Subject: Issuance of Amendment No. 79 to Facility Operating License NPF-6 -
Arkansas Nuclear One, Unit No. 2

The amendment revises the Technical Specifications pertaining to the Core Protection Calculators (CPC) as a part of the CPC Improvement Program.

Amendment No. 79
License No. NPF-6

ATTACHMENT TO LICENSE AMENDMENT NO. 79

Figure 3.2-1 Allowable Peak Linear Heat Rate vs Burnup (COLSS out of service)

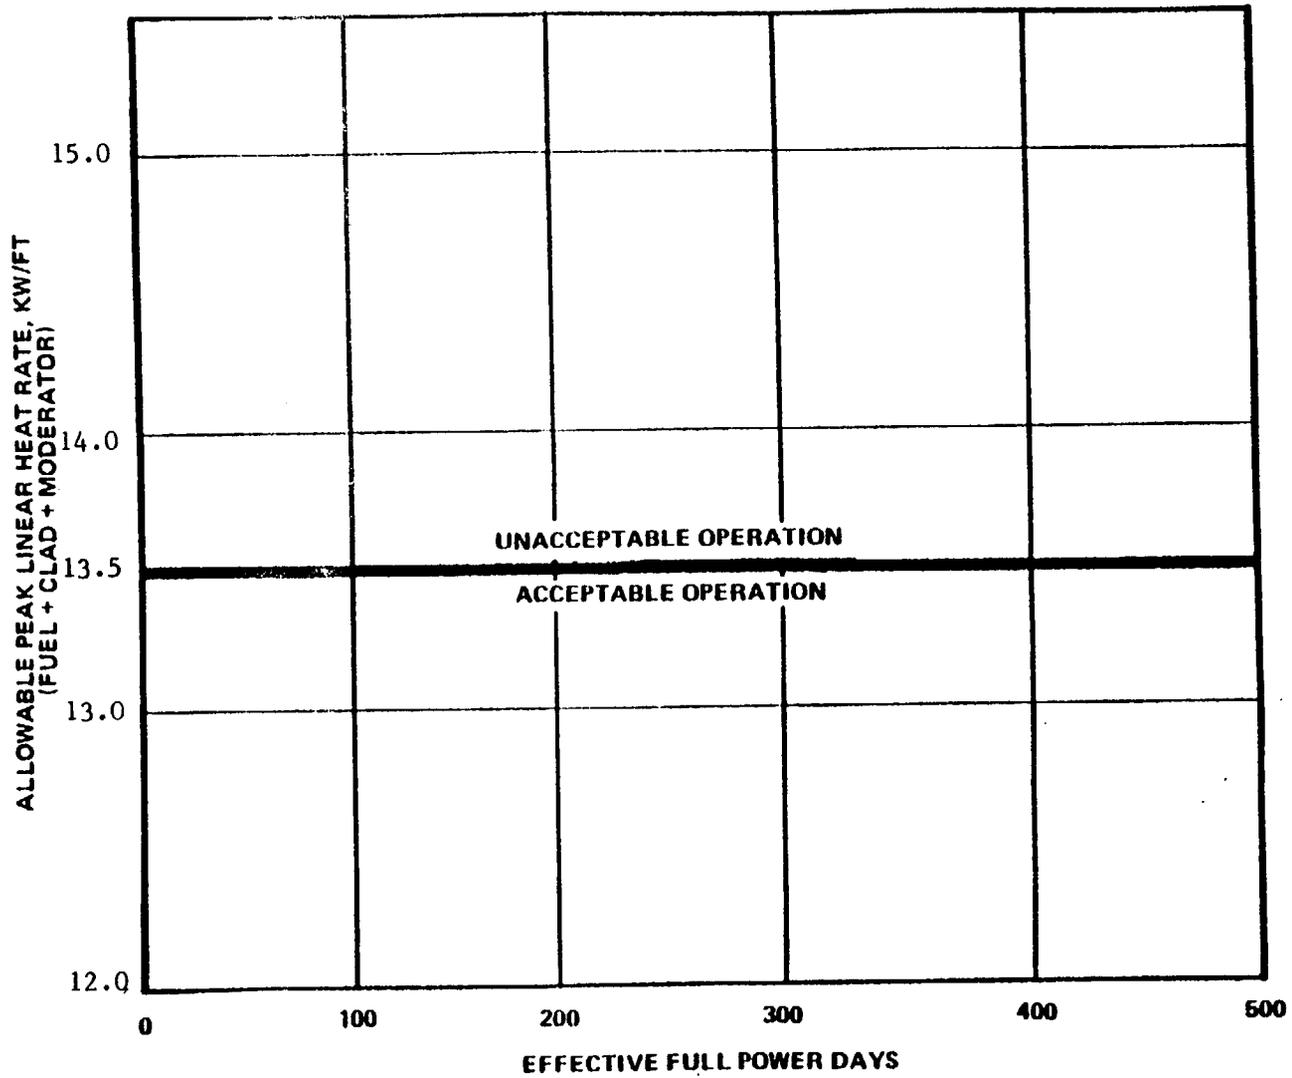
- a. Maintaining COLSS calculated core power less than or equal to COLSS calculated core power operating limit based on linear heat rate (when COLSS is in service); or
- b. Operating within the region of acceptable operation of Figure 3.2-1 using any operable CPC Channel (when COLSS is out of service).

The previous Limiting Condition for Operation (LCO) of Technical Specification 3.2.1, "Linear Heat Rate," has been replaced with two parts, 3.2.1.a and 3.2.1.b. Specification 3.2.1.a is applicable when COLSS (Core Operating Limits Supervisory System) is in service and requires the COLSS calculated core power to be maintained less than or equal to the COLSS calculated Power Operating Limit (POL) based on linear heat rate. These words replace the old Figure 3.2-1 and state the same requirement. The change is, therefore, acceptable. Specification 3.2.1.b is applicable when COLSS is out of service and requires operation within the allowable region of the new Figure 3.2-1 using any operable CPC channel. The old Figure 3.2-1 has been deleted and replaced with the words of Specification 3.2.1.a which state the same requirements. The new Figure 3.2-1 is similar to the previous Figure 3.2-2 and gives the allowable peak linear heat rate as a function of burnup when COLSS is out of service. The linear heat rate limit value in this figure has been lowered from 14.5 kw/ft to 13.5 kw/ft in order to bound future cycles. Since this lower limit is more restrictive and in a conservative direction, the change is acceptable.

FIGURE 3.2-2

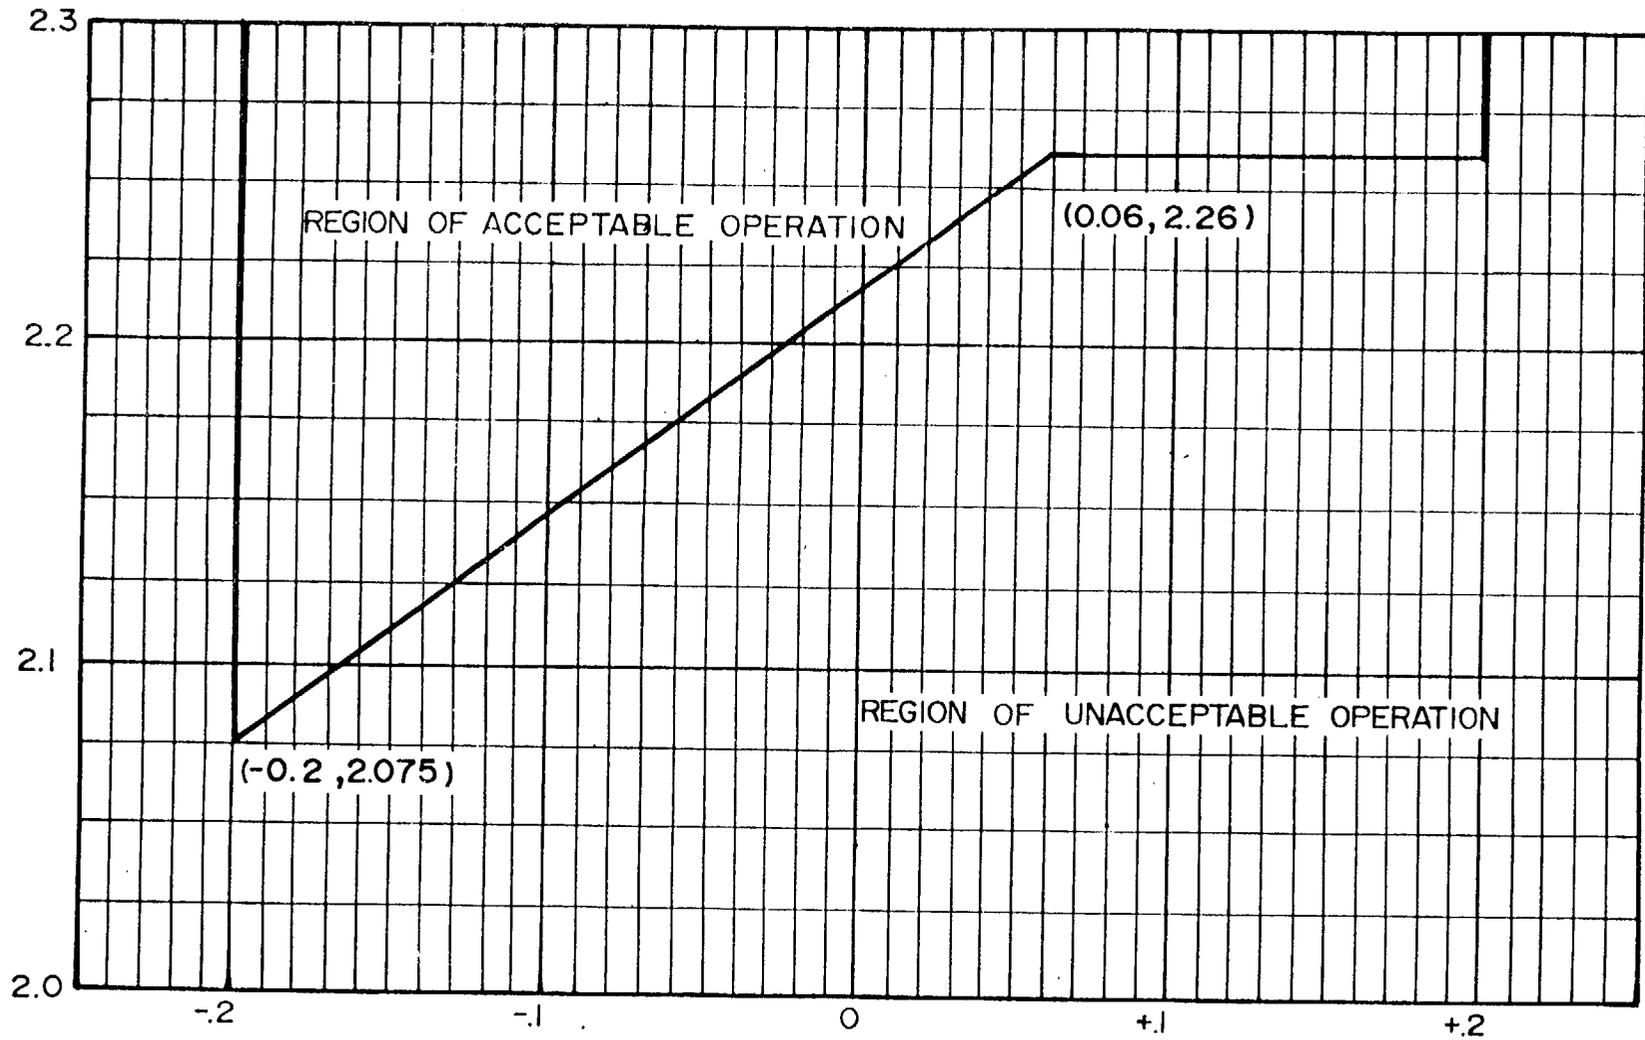
Parameters required to maintain the margin to DNB and total core power are also monitored by the CPCs. Therefore, in the event that the COLSS is not being used, operation within the limits of Figure 3.2-2 for CEAC operable or Figure 3.2-3 for both CEACs inoperable can be maintained by utilizing a predetermined DNBR as a function of AXIAL SHAPE INDEX and by monitoring the CPC trip channels. The above listed uncertainty and penalty factors are also included in the CPC.

The previous LCO of Technical Specification 3.2.4, "DNBR Margin," has been replaced with four parts, a, b, c, and d. Specification 3.2.4.a is applicable when COLSS is in service and at least one Control Element Assembly Calculator (CEAC) is operable and requires the COLSS calculated core power to be maintained less than or equal to the COLSS calculated POL based on DNBR. This is consistent with the previous requirement except that Figure 3.2-3 has been deleted and replaced with words to the same effect. The change is acceptable. Specification 3.2.4.b is applicable when COLSS is in service and neither CEAC is operable and requires the COLSS calculated core power to be maintained less than or equal to the COLSS calculated POL based on DNBR decreased by a penalty factor of 13% of rated power.

FIGURE 3.3-1

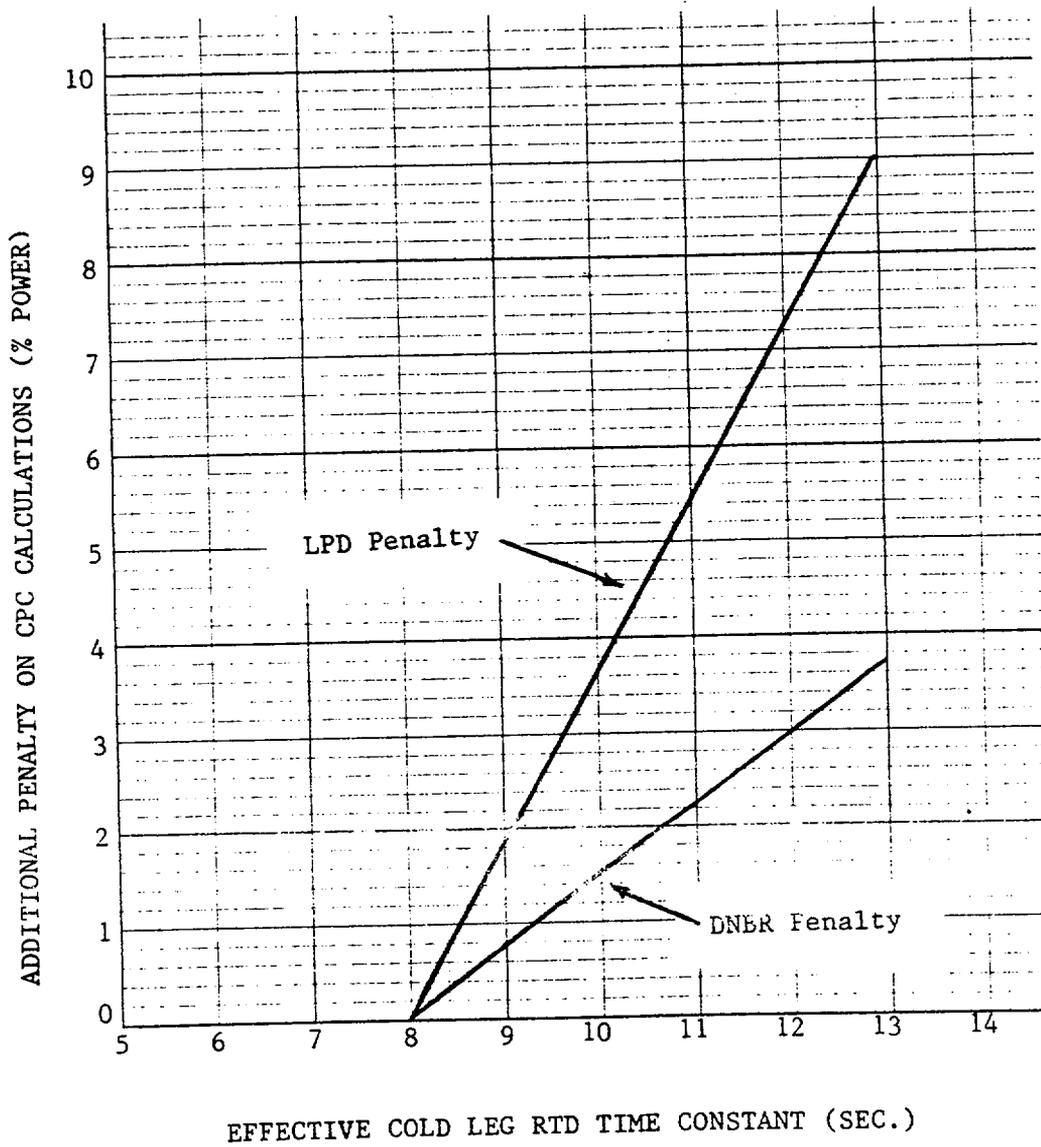
##Based on an effective resistance temperature detector (RTD) response time of ≤ 8.0 seconds. If the effective RTD time constant for a CPC channel exceeds 8.0 seconds, the DNBR and LPD penalties for the affected channel(s) shall be increased by the amount indicated on Figure 3.3-1.

The resistance temperature detector (RTD) response time of 6 seconds for a CPC channel, shown in the footnote to Table 3.3-2 of Technical Specification 3.3.1, has been revised. The CPC Improvement Program and related accident analyses now assume effective response times of 8 seconds for the RCS cold leg temperature RTDs and 13 seconds for the RCS hot leg temperature RTDs. The footnotes to Table 3.3-2 are revised accordingly. Figure 3.3-1 is also revised to give the DNBR and linear heat rate penalties to be applied if the effective cold leg RTD response time falls between 8 seconds and 13 seconds. Table 3.3-3 is deleted since the analyses now assumes response times up to 13 seconds and adjustments are no longer required for RTD response times less than this. These changes are acceptable.
